Beacon Hill

DESIGN REVIEW

PROJECT# 3008621

RECOMMENDATIONS PACKET

SITE PLAN

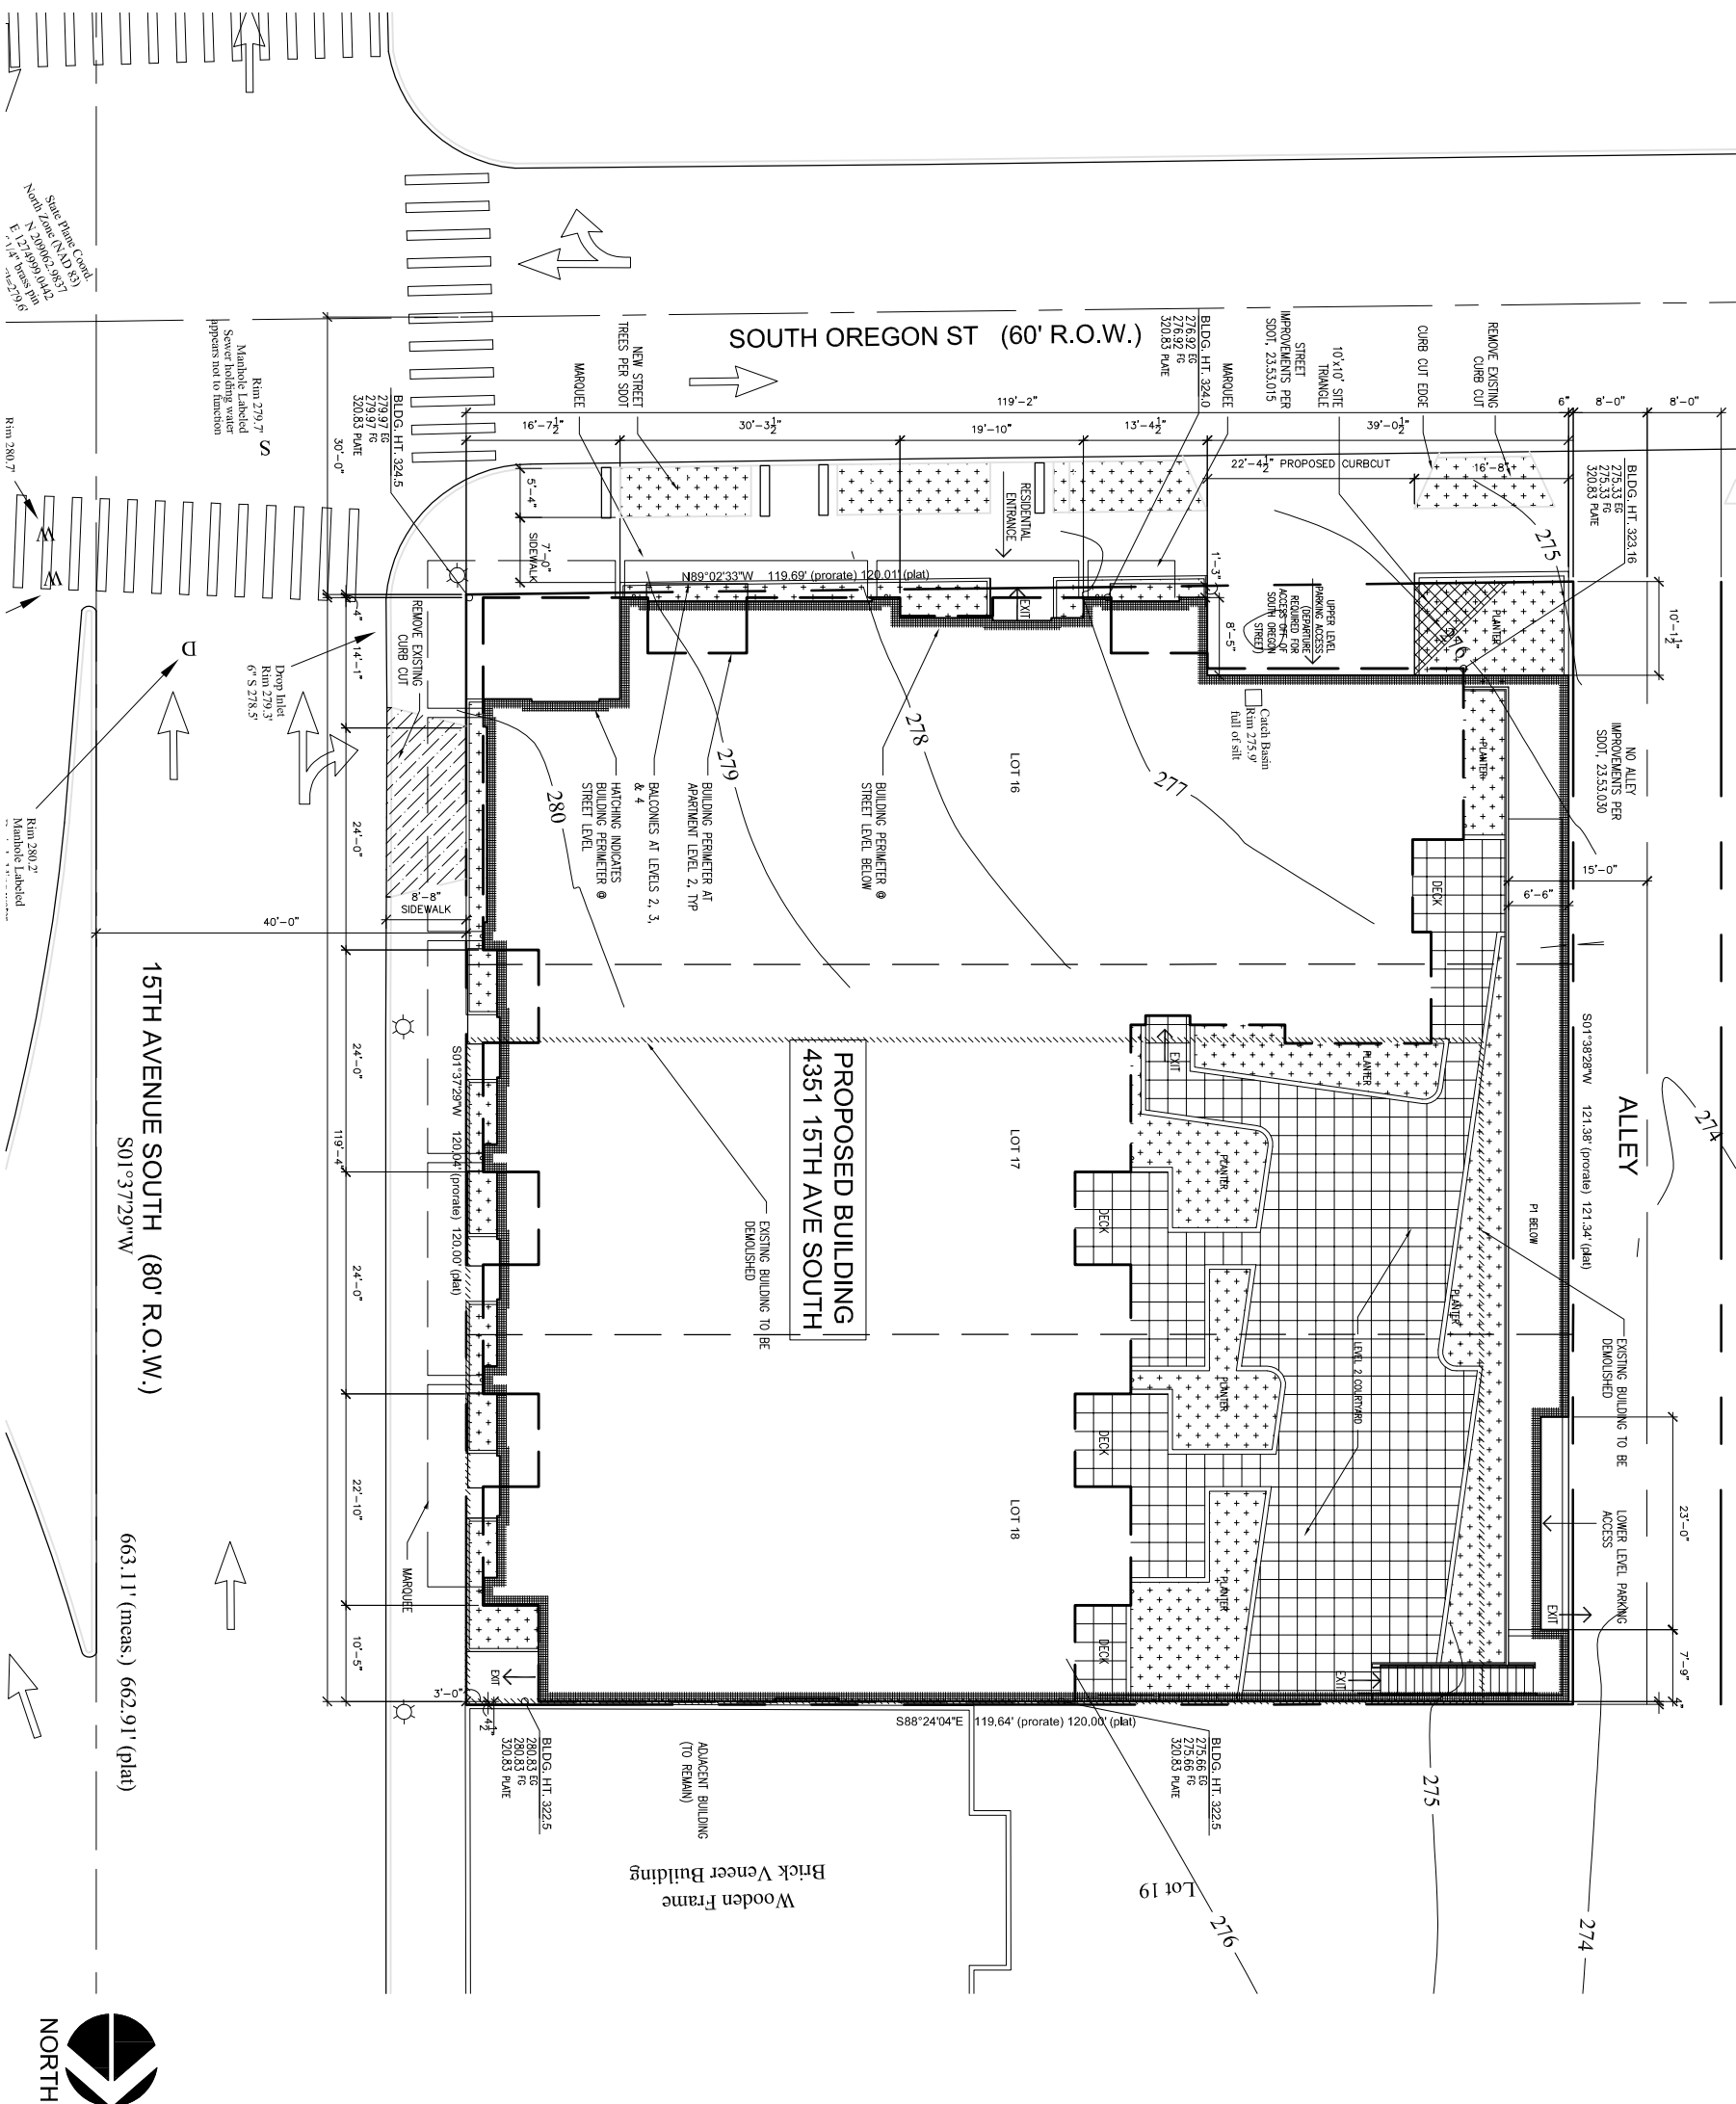
COMMENT

Board members are not satisfied with the single design option of parking access points to the site, which are presented the same in each of the three alternatives; along South Oregon Street and along the alley west of the site. The Board feels that since there is an alley available, and since the site is large enough and relatively flat, the applicant should present a design option(s) that proposes all access to the site from the alley. Not only is this a direct code requirement, albeit deparatable, but also addresses pedestrian safety along the right-of-way and increases the potential for enhancing the residential entry.

The above item ties in with another issue the Board has with the design at the street level along South Oregon Street, which is that the proposed residential entry off South Oregon Street appears to be a "cavernous dark zone". The residential entry should be clearly identifiable and visible from the street and should be safely separated from any vehicular entrance. As one Board member stated, the residential entres should "pop" out and should not be adversely impacted by a parking access door or entryway.

We have studied the parking issue and in response to the EDG, have conceived an alternative that allows all parking access off of the alley. For use of clarification in comparing parking schemes, refer to the scheme presented at the EDG meeting with parking access off of the alley and S. Oregon St. as the "original" scheme. The new scheme with **all** parking access off of the alley is the "alternate" scheme. The alternate scheme places one garage door at the south end of the alley and one garage at the north end of the alley. To facilitate the newly placed garage entrance at the south end of the alley, an aggressive curved ramp must be used. The negative element is the ramp size and layout compromises the number of stalls at each parking tier. The alternate scheme yields 45 stalls (the required amount for the project is 39) and the original scheme yields 51 stalls. As strongly expressed by numerous members of the public, the number of parking spaces for retail use is extremely important. The alternate scheme allows for the required minimum for retail parking spaces at 9. The original scheme would allow for over double the required amount of retail parking at 20.

Another important factor when comparing the two schemes is how each scheme affects the exterior of the building. A strong point with the original scheme was that the garage entrance off of South Oregon Street was set back from the sidewalk nearly ten feet, further breaking down the building mass as it nears the single family residence to the West. With the alternate scheme, due to the space needed for the ramp, the southwest corner of the building is pulled out to the corner of the lot.

For the original scheme, to address pedestrian safety, a 10 x 10 site triangle is required for cars to clearly see the sidewalk when exiting the building. As for the alternate scheme, traffic for the whole building is now channeled down the alley and when driving South down the alley as you approach the sidewalk of South Oregon Street, you are not able to see the sidewalk until you reach it. When considering pedestrian safety, the original scheme is safer in that the Southeast corner of the building is pulled away from the sidewalk giving drivers a chance to see the sidewalk before they reach it.

While having all of the parking access off of the alley is the preferred method for development by Seattle zoning, we feel having access off of South Oregon Street will encourage retail users to park in the garage for the simple reason it highly visible and closer to the retail. For the alternate scheme, unfamiliar retail users would have to explore down the alley to find parking. A member of the public expressed concern for having too much traffic down the alley and having the retail user park on the residential streets. The original scheme cuts down the number of cars travelling down the alley in that retail parking is offered from S Oregon St. The alternate scheme directs all associated building traffic into the alley and could increase the probability of retail users not using the garage.

The residential entryway has been improved greatly from the EDG presentation. It no longer has an exterior ramp and is no longer set back into the building. This newly designed entry has large windows and is integrated with the overall commercial base as not add another unnecessary deign element. Signage and location on the more residential street will direct visitors to the entry. This design works for both the alternate and the original parking entrance scheme.

SE CORNER PERSPECTIVE

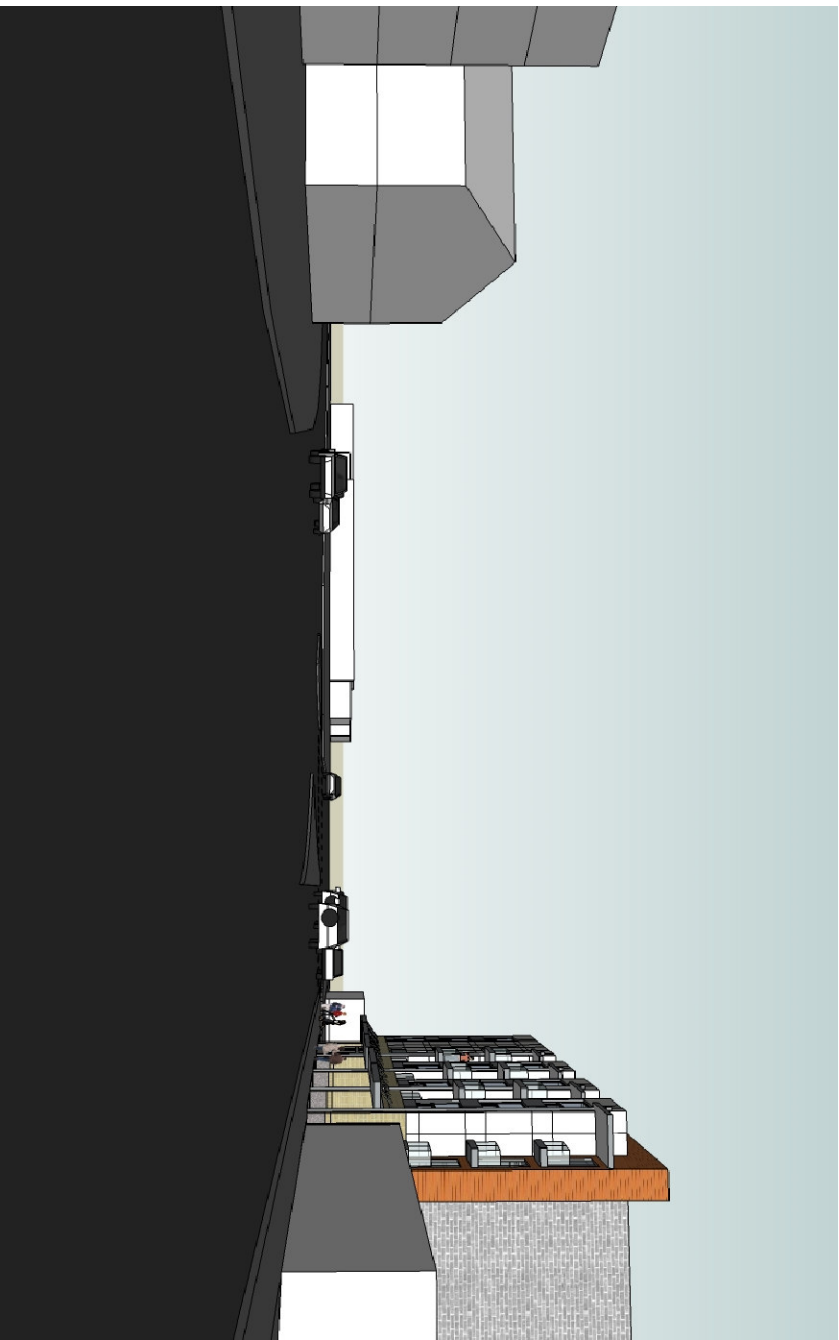
This is a prominent corner site, one that catches the attention of motorists and pedestrians from all aspects of the intersection; from the southeast along South Columbian Way, from the north and south along 15th Avenue South, and from the east and west along South Oregon Street. The Board, and members of the public, feel that this corner represents a "landmark" for the area, an important center of energy that needs to be managed and balanced in a way that is not overpowering for the low-density commercial zone (NC1-40), and that respects the adjacent single family zone (SF 5000).

The Board feels that the current corner design concept is not appropriate for the site and should develop a stronger connection with the distinct character of the neighborhood, which as members of the public stated "is not like Ballard, Queen Anne, or Lake City". The Board suggested creating a design that "celebrates" the corner and creates an "activity zone". The design should be compatible with, and should respond to, the surrounding neighborhood character.

For the next phase of the Design Review process, the applicant should present new options/studies for corner design of the site. The Board looks forward to seeing options that encourage activity and community interest at the street level; that does not over-power the corner, but rather ties in well with the other corners of the intersection, such as with MacPherson's Fruit and Produce Stand to the southeast. The design at the street level should include sufficient lighting as to make the corner safe and inviting, should include overhead weather protection (along both street fronts), and should incorporate treatment options such as special pavement materials, plantings, street furniture, etc. The design should include quality materials, as is the case with much of the older residential and commercial development in the Beacon Hill neighborhood. The Board strongly recommends using brick masonry.

The corner should be prominent; the structure should provide distinct, albeit cohesive elements - strong commercial base, middle, top elements - both horizontally and vertically. Additionally, the site includes one corner with two distinct street edges. Fifteenth Avenue South is retail and commercially oriented, while South Oregon Street offers a gateway into the residential zone to the west. Each street level should include design options applicable to uses along the street; the building should not have to include one symmetrical corner treatment.

The corner of the site is very prominent from all directions where 15th Ave South intersects with S Columbia Way and S Oregon St. It is our intent that it remain as a landmark for locals. Unlike the first design presented where the corner was a standout feature, the current corner design is more in tune with the rest of the building. Along S 15th Ave, there is a rhythm of 3 bays and the corner is pronounced by a larger section of the same materials used at the bays. Turning the corner to the more residential S Oregon St, the corner is proportioned smaller to de-emphasize the corner. At ground level, the doors to the corner retail space are recessed into the corner providing a larger pedestrian area for what could become an active crossing. Additionally, at street level the metal marquees running down 15th Avenue South and South Oregon Street wrap the corner offering additional weather protection to those waiting at the corner to cross the street. As strongly expressed by multiple members of the public, it is extremely important to achieve quality retail. Retail frontage for the whole building maximizes glazing for the most transparency that encourages use. To add interest and increase safety, light fixtures are located at each brick column along the sidewalk for 15th Ave South and South Oregon St.

The request to make building unique to Beacon Hill was difficult to assess since Beacon Hill doesn't have its own architectural language, especially pertaining to multi-family structures. Rather than attempting to blend in with the eclectic neighborhood buildings, we have taken a more contemporary approach to the one that was first presented at the EDG meeting. We believe this brings a more unique feel to the building and separates it from any other neighborhood. There is a unifying element that is used widely among Beacon Hill buildings, which is brick. Brick is predominantly used in our local vicinity among commercial buildings and residences in the SF zone directly to the West of the site. We have utilized brick along the street level at 15th Ave South and S Oregon Street, it mimics the scale and mass of adjacent properties.

We integrated benches into the planting strip along S Oregon St. Another issue brought up was new plantings. Plantings along the sidewalk of 15th Ave South in the right of way are not allowed since sidewalk is too narrow. However, by pulling the building off of the street and recessing the retail entrances, we were able to add ground floor plantings within our property. By implementing planting areas at the base of the building, the effect is that the building is grounded. Similar planting beds continue down S Oregon St.

VIEW LOOKING NORTH FROM ALLEY

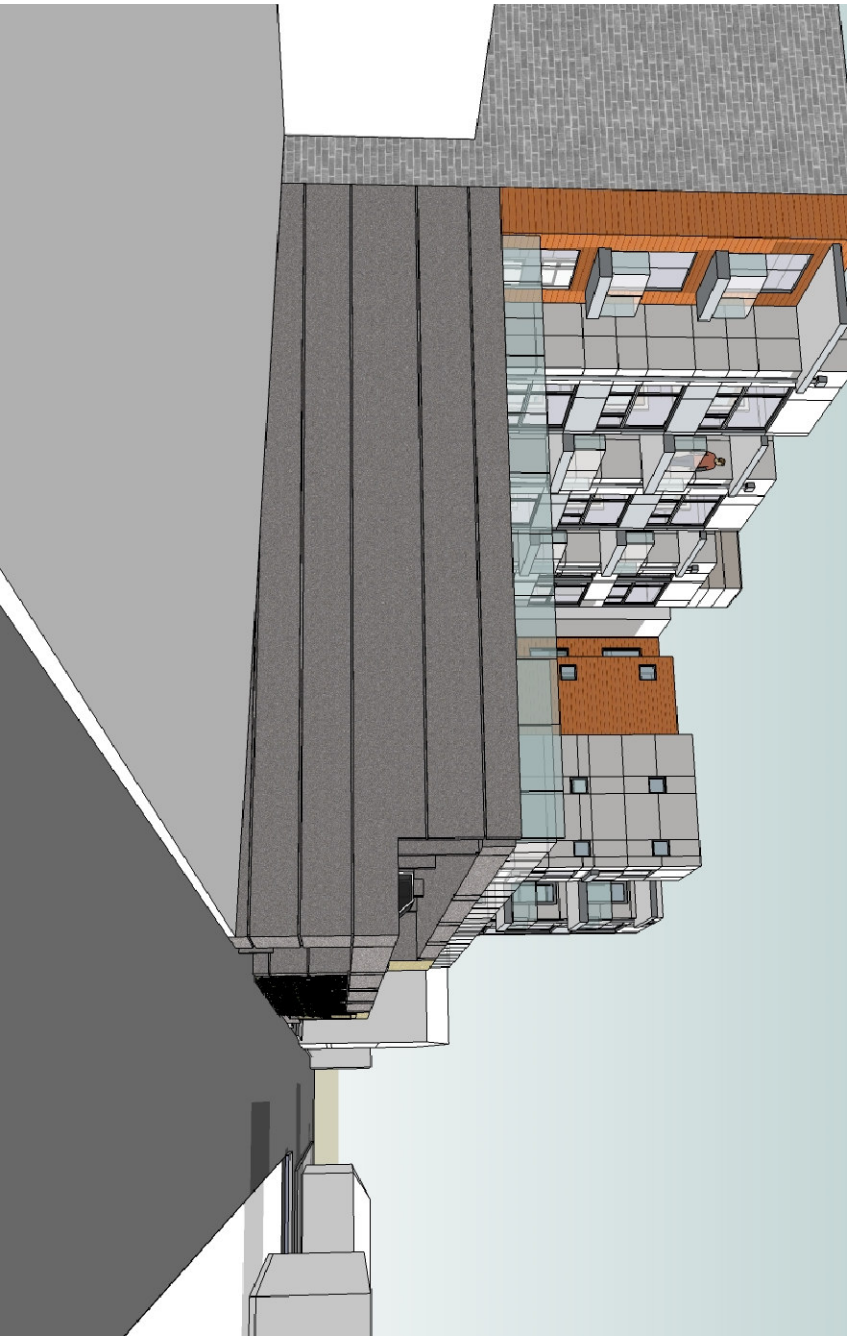
The Board would like to see options for treatment of the alley facade. Currently, the proposed design concept presents a solid blank mass. The Board would like to see the applicants continue exploring design concepts for the alley wall, which would go a long way in alleviating scale impacts on the single family zone to the west, and would add to pedestrian and motorist safety and security along the alley. Several options should be considered, such as a green wall, textured wall, articulated wall, color-treated wall, public art (as one member of the public added), light wells - employing multiple creative variations on texture, materials, and lighting.

Approaching the alley from S Oregon St, the first 15'-6" of the alley wall is clad in brick. The same brick facade that runs along Oregon and 15th. Additionally the proposed alley treatment features horizontal reveal lines with deeper recessed portions of wall that give the effect of having columns. This emulates the front side of the building where you have the repetition of columns and storefront windows. This dramatically breaks up the length of the wall. To soften the concrete wall we are proposing a green screen in the three recessed areas. The alley wall is located 6" off of the west property line to facilitate the growth of the green screen. A local example of a similar green screen can be found in the alley behind the Fremont PCC.

Lighting would be placed at each column. The lighting would carefully be selected as to cast light on the wall and the surface of the alley and not adjacent properties

From the required setback, (23.47A.014B rear setback requirement for lots adjacent to residential zones), the immediate wall at the alley can not be higher than 13 feet tall. The wall is only 11'-7" tall at the south end of the alley and at the north end the wall is less than 13 feet high. At the 13 feet height limit, the wall steps back 6'-6". Further breaking down the scale, glass panels and planting beds are used at the edge of the courtyard at level 2 above.
